Access Compliance Report

Public Rights-of-Way

(Curb Ramps)

Intersection ID: 50617	Main Street: GOLDEN_WOOD_LN	Cross Street: PADDLE_OAK_RD	Location: SW
ADA ID: E07FB32CB494	Ramp Type: Perp	Initial Pass/Fail: Fail	Overall Compliance: No
Severity Score: 33.75			
Codes/Mitigation Info/Possible Solution		Field Measurements/Component Compliance

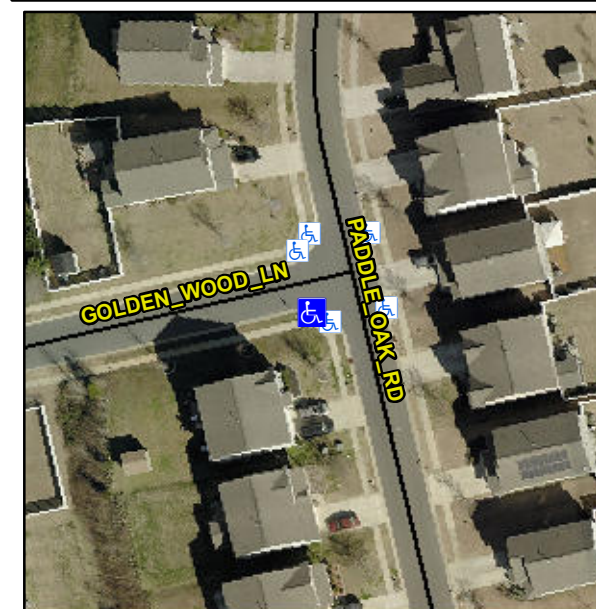
R304.5.1, R304.2.2, R304.5.3

Compliance	Description	Data	Compliance	Description	Data
N/A	Ramp Length (in)	48.0	No	Ramp Slope (%)	9.2
No	Ramp Width (in)	47.5	No	Ramp XSlope (%)	5.6
N/A	Flare Type LT	N/A	N/A	Flare Type RT	N/A
N/A	Flare Slope LT (%)	N/A	N/A	Flare Slope RT (%)	N/A
N/A	Flare Traversable LT?	N/A	N/A	Flare Traversable RT?	N/A
N/A	Landing Length (in)	N/A	N/A	DWS Provided?	N/A
N/A	Landing Width (in)	N/A	N/A	DWS Contrast?	N/A
N/A	Landing Slope (%)	N/A	N/A	DWS Length (in)	N/A
N/A	Landing X Slope (%)	N/A	N/A	DWS Full Width?	N/A
N/A	Landing Curb? (Y/N)	N/A	N/A	DWS Offset (in)	N/A
N/A	Shared Landing?	N/A			
N/A	Gutter Ponding?	N/A	N/A	Gutter Slope (%)	N/A
N/A	Gutter Lip Ht (in)	N/A	N/A	Gutter X Slope (%)	N/A
N/A	Painted X Walk1?	No	N/A	Painted X Walk2?	N/A
	X Walk 1 Direction	To N		X Walk 2 Direction	N/A
N/A	X Walk 1 Width (in)	N/A	N/A	X Walk 2 Width (in)	N/A
	X Walk 1 Slope (%)	0.9		X Walk 2 Slope (%)	N/A
	X Walk 1 X Slope (%)	3.3		X Walk 2 X Slope (%)	N/A

Remove & Replace Entire Ramp.
